Access Compliance Report

Public Rights-of-Way

Intersection ID: 10023892	Main Street: COMMUNITY_HOUSE_RD	Cross Street: N/A	Location: NE
ADA ID: 5694F3E89C70	Ramp Type: Perp	Initial Pass/Fail: Pass	Overall Compliance: No
Severity Score: 0.25			
Codes/Mitigation Info/Possible Solution		Field Measurements/Component Compliance

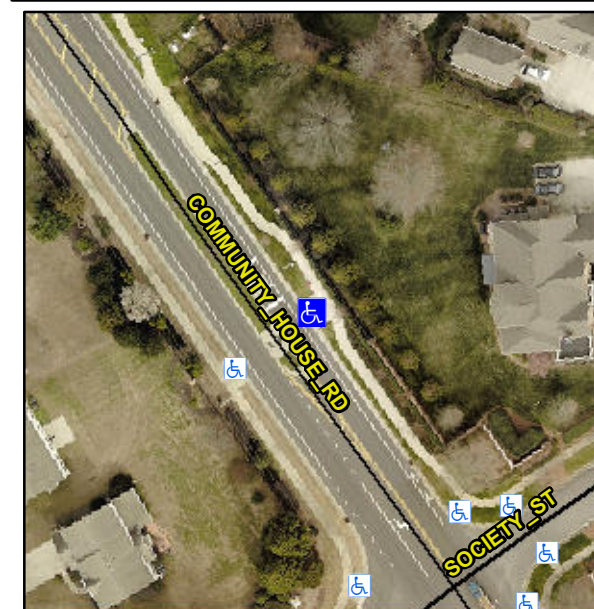
R304.5.3, R305.2

Compliance	Description	Data	Compliance	Description	Data
N/A	Ramp Length (in)	96.0	Yes	Ramp Slope (%)	5.2
Yes	Ramp Width (in)	50.0	No	Ramp XSlope (%)	2.9
N/A	Flare Type LT	Sloped	N/A	Flare Type RT	N/A
N/A	Flare Slope LT (%)	6.3	Yes	Flare Slope RT (%)	4.8
N/A	Flare Traversable LT?	Yes	N/A	Flare Traversable RT?	Yes
Yes	Landing Length (in)	71.0	Yes	DWS Provided?	Yes
Yes	Landing Width (in)	50.0	Yes	DWS Contrast?	Yes
Yes	Landing Slope (%)	1.3	Yes	DWS Length (in)	24.5
Yes	Landing X Slope (%)	1.5	Yes	DWS Full Width?	Yes
N/A	Landing Curb? (Y/N)	No	No	DWS Offset (in)	5.0
N/A	Shared Landing?	No			
Yes	Gutter Ponding?	No	Yes	Gutter Slope (%)	2.8
Yes	Gutter Lip Ht (in)	0.0	Yes	Gutter X Slope (%)	2.3
N/A	Painted X Walk1?	No	N/A	Painted X Walk2?	N/A
	X Walk 1 Direction	To SW		X Walk 2 Direction	N/A
N/A	X Walk 1 Width (in)	N/A	N/A	X Walk 2 Width (in)	N/A
	X Walk 1 Slope (%)	4.2		X Walk 2 Slope (%)	N/A
	X Walk 1 X Slope (%)	2.8		X Walk 2 X Slope (%)	N/A

Remove & Replace Entire Ramp.
